Access Compliance Report

Public Rights-of-Way

Intersection ID: 13715	Main Street: E_MOREHEAD_ST	Cross Street: MYRTLE_AV	Location: W
ADA ID: 585826258D16	Ramp Type: PerpDiag	Initial Pass/Fail: Fail	Overall Compliance: No
Severity Score: 13.75			
Codes/Mitigation Info/Possible Solution		Field Measurements/Component Compliance

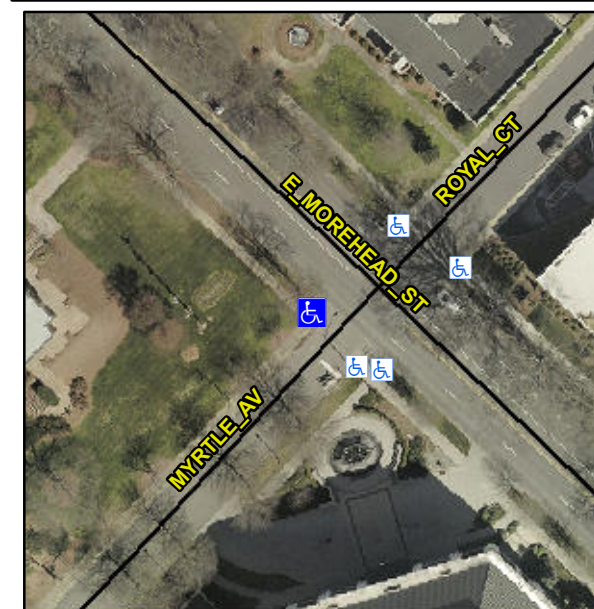
Not Found, R304.2.2, R304.5.3

Compliance	Description	Data	Compliance	Description	Data
N/A	Ramp Length (in)	72.0	No	Ramp Slope (%)	10.1
Yes	Ramp Width (in)	48.0	No	Ramp XSlope (%)	2.7
N/A	Flare Type LT	N/A	N/A	Flare Type RT	N/A
N/A	Flare Slope LT (%)	N/A	N/A	Flare Slope RT (%)	N/A
N/A	Flare Traversable LT?	N/A	N/A	Flare Traversable RT?	N/A
N/A	Landing Length (in)	N/A	N/A	DWS Provided?	N/A
N/A	Landing Width (in)	N/A	N/A	DWS Contrast?	N/A
N/A	Landing Slope (%)	N/A	N/A	DWS Length (in)	N/A
N/A	Landing X Slope (%)	N/A	N/A	DWS Full Width?	N/A
N/A	Landing Curb? (Y/N)	N/A	N/A	DWS Offset (in)	N/A
N/A	Shared Landing?	N/A			
N/A	Gutter Ponding?	Yes	N/A	Gutter Slope (%)	N/A
N/A	Gutter Lip Ht (in)	N/A	N/A	Gutter X Slope (%)	N/A
N/A	Painted X Walk1?	No	N/A	Painted X Walk2?	No
	X Walk 1 Direction	To SE		X Walk 2 Direction	To NE
N/A	X Walk 1 Width (in)	N/A	N/A	X Walk 2 Width (in)	N/A
	X Walk 1 Slope (%)	1.7		X Walk 2 Slope (%)	2.3
	X Walk 1 X Slope (%)	3.8		X Walk 2 X Slope (%)	1.9

Remove & Replace Curb Ramp With Two New Directional Ramps or Equivalent.
